User-Led Accessibility Audit (ULAA) Grand Report

Date of Grand Report: 11 August 2025

B1. Enabled Rooms (On-Campus and Halls)

B2. The Hamilton Complex

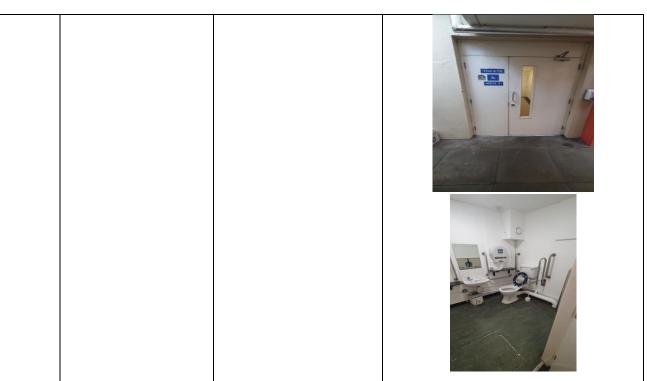
Ham14 Joly Lecture Theatre – Seating Arrangements	Sufficient seating space for wheelchair access at the back of the theatre should be implemented as gold standard for all teaching spaces.	Use this as a model for other teaching spaces.	
	Inaccessible without intervention but use of	Maintain access to this accommodation and ensure	
Ham15	free-standing height-	an appropriate number of	
All labs – access to	adjustable desk has been	adjustable tables are	N/A
workspace	used for students with	available to accommodate	
	mobility issues in the past.	student demand. Designate	
	Difficulty accessing fume	an accessible area and

aunhaarda aa raguira d	provide essistance for	
	cupboards as required	provide assistance for	
	during experiments.	accessing fume cupboards.	
Ham16 All labs — Access to sink	No under access sink in present in any of the labs.	Install a free standing under access sink as discussed with Chief Technician	
Ham17 Bathroom – ground floor	Located just past the Security Desk. Access obstructed by two-heavy automated doors. Lack of maneuvering space and sink obstructed by electrical box.	Automate the doors, clear obstructions around the sink.

TBS05
Lack of suitable
accessible seating
arrangements in
main teaching
spaces

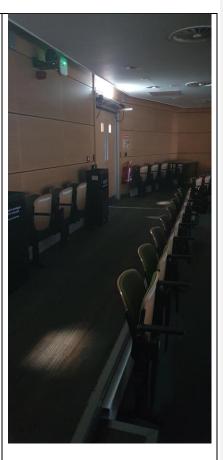
No suitable accessible seating arrangements are present in Stanley Quek or Tercentenary Hall lecture theatres. Desks are present at the front of each theatre but these are impractical due to the location of the projector. Users have cited neck pain as a result.

Plans are in motion to create accessible seating areas at the back of these teaching spaces following the approval of funding. Keep updated on the works.
